Appendix F

Revised CS&P Drawings

DRAINAGE LAYOUT

Client	Simply UK	 CHARLES SCOTT & PARTNERS CONSULTING ENGINEERS
Location	HOOK LANE, PAGHAM, PO21 3PB	
Drawing Title	ST1-ST3 GRAF ECOBLOC DETAILS

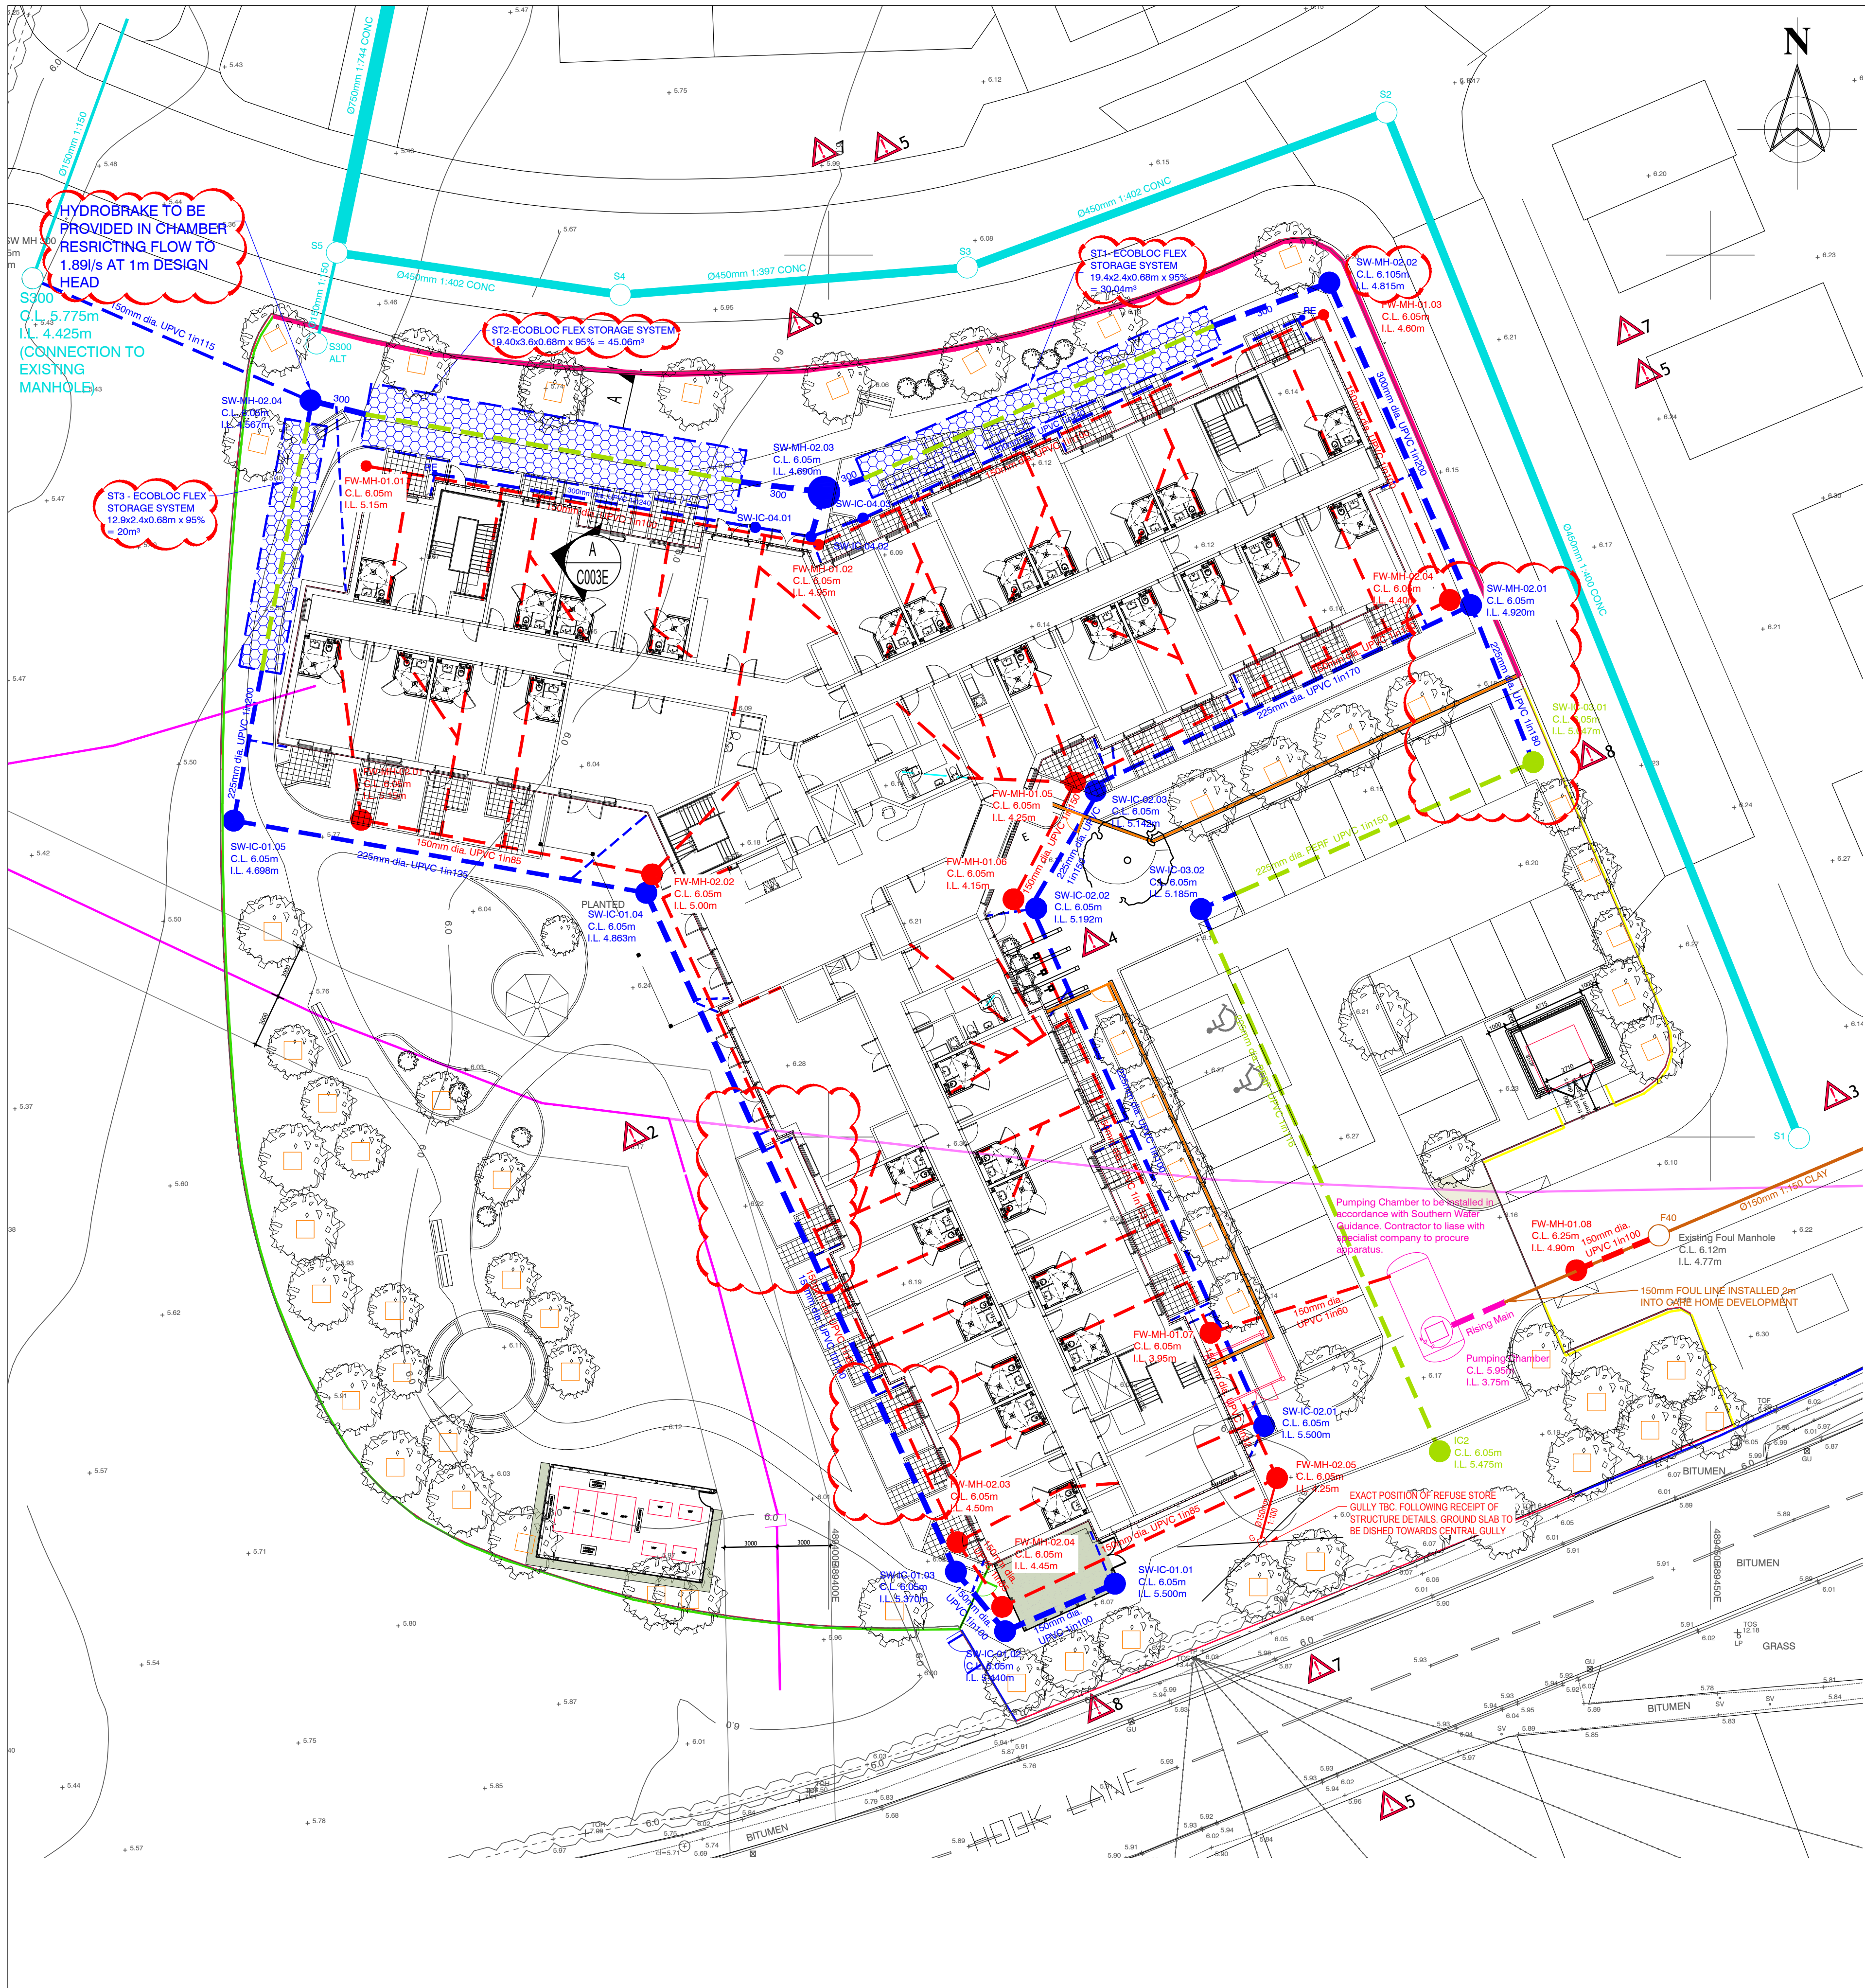
U	Ecobloc spec. & notes amended as clouded.	12/11/25	CM	LC
T	Revised as clouded	Aug/25	CM	LC
S	Tree PL locations added	Mar/25	EM	LC
R	Rising Main Discharge Rate amended	Mar/25	JPC	BM
Q	150mm Pop-Up Pipes added to Assisted Bath areas as requested by client. SW-C-03.02 and SW-C-03.01	Mar/25	JPC	BM
P	Position and Invert Level revised	Feb/25	JPC	BM
L	Layout updated to comply with comments from Planning Application	Feb/25	JPC	BM
O	Both 40mm Waste Pipes added to Assisted Bath areas	Feb/25	JPC	BM
N	FW-MH-01.07 position & inlet to pumping station amended	Dec/24	SC	
M	Shower Foul Pipes Updated	Dec/24	JPC	SC
L	Refuse Store Gully Note Added	Dec/24	EM	SC
K	Surface Water Updated To Suit	Nov/24	EM	LC
J		Sep/24		
I	Pumping Chamber Location Shifted To Suit	Sep/24	EM	BM
H	Updated To Suit Latest Architects Layout	Aug/24	EM	LC
G	Surface And Foul Routes At Right Side Altered	Aug/24	EM	LC
F	Stormcell Dimensions Altered To Suit	Aug/24	EM	LC

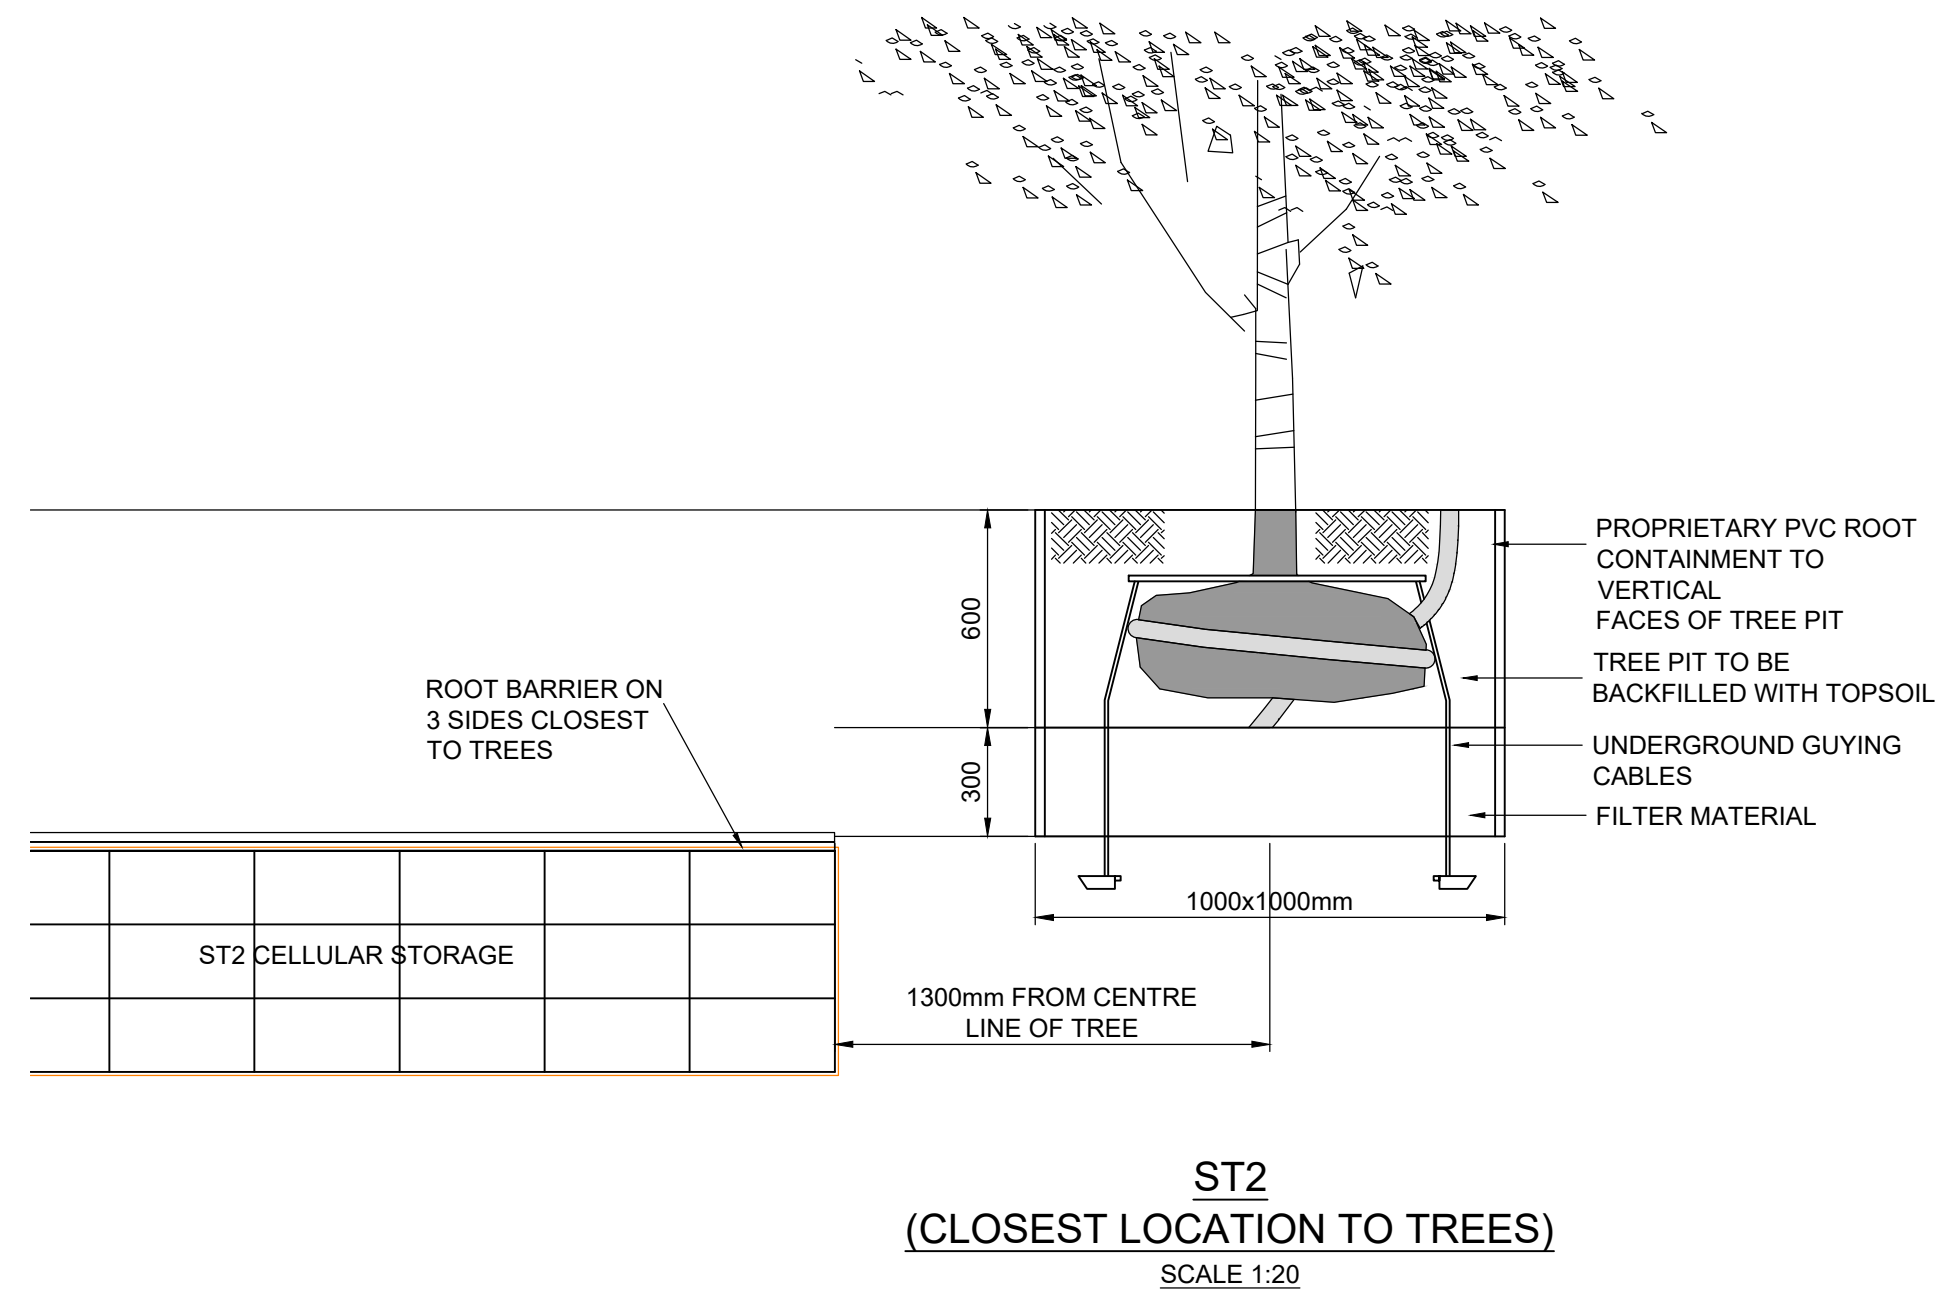
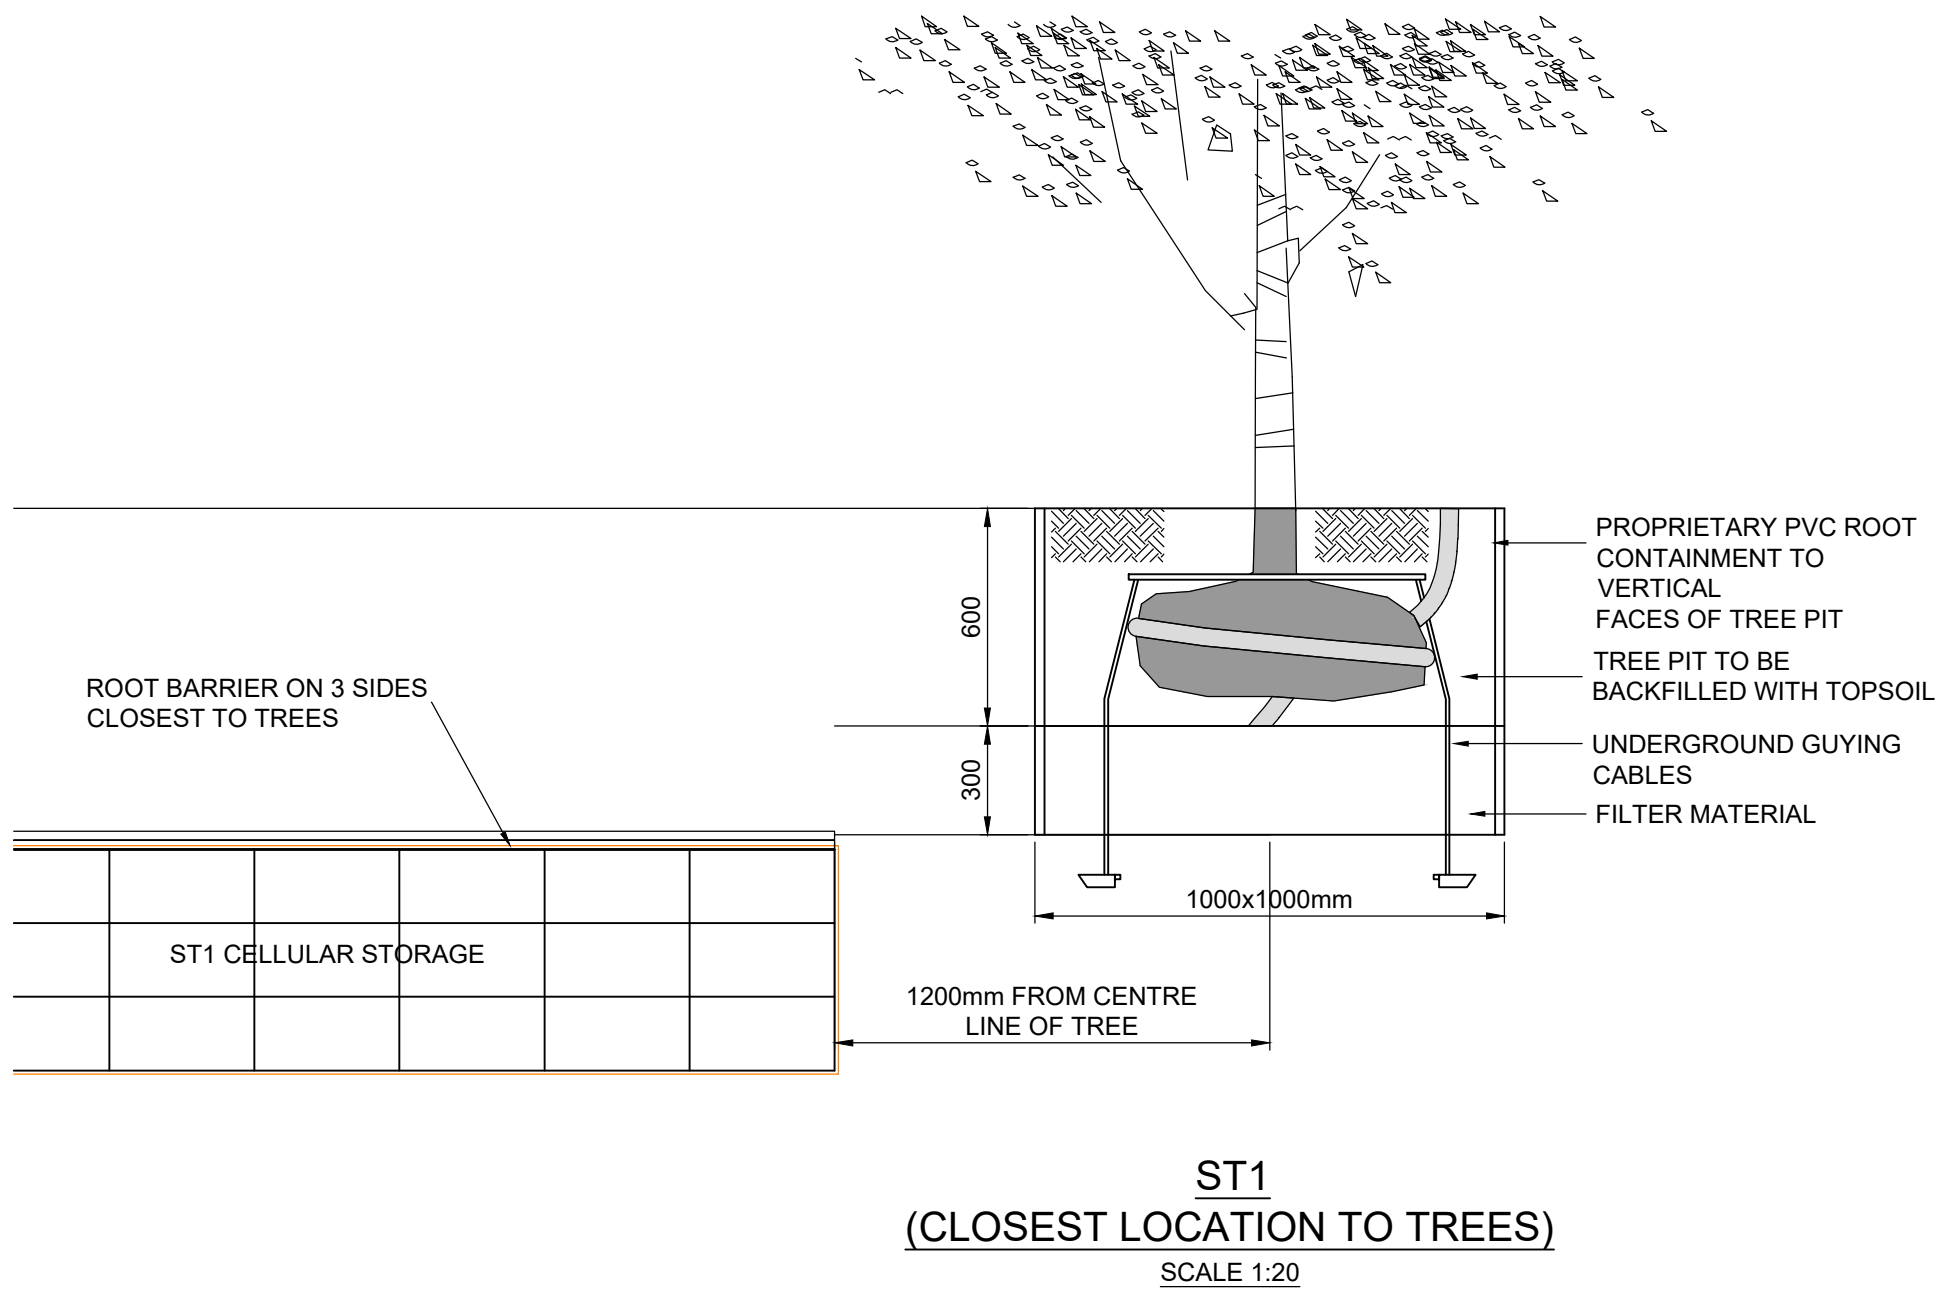
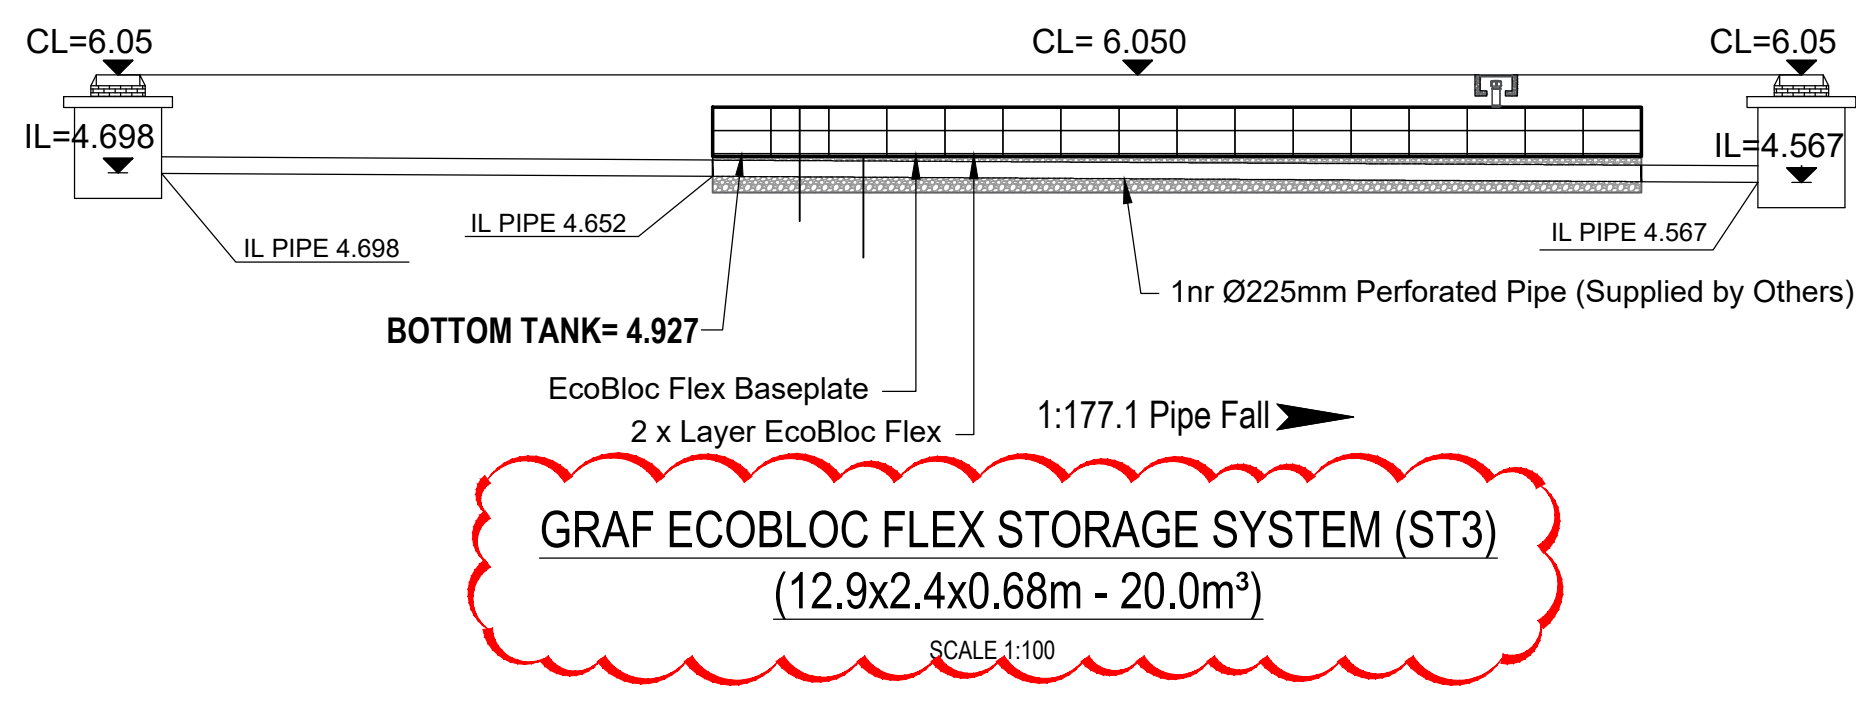
Rev.	Description	Date	Initials	Checked
A	ECOBLOC SPEC. REVISED AS CLOUDED	12.11.25	CM	LC
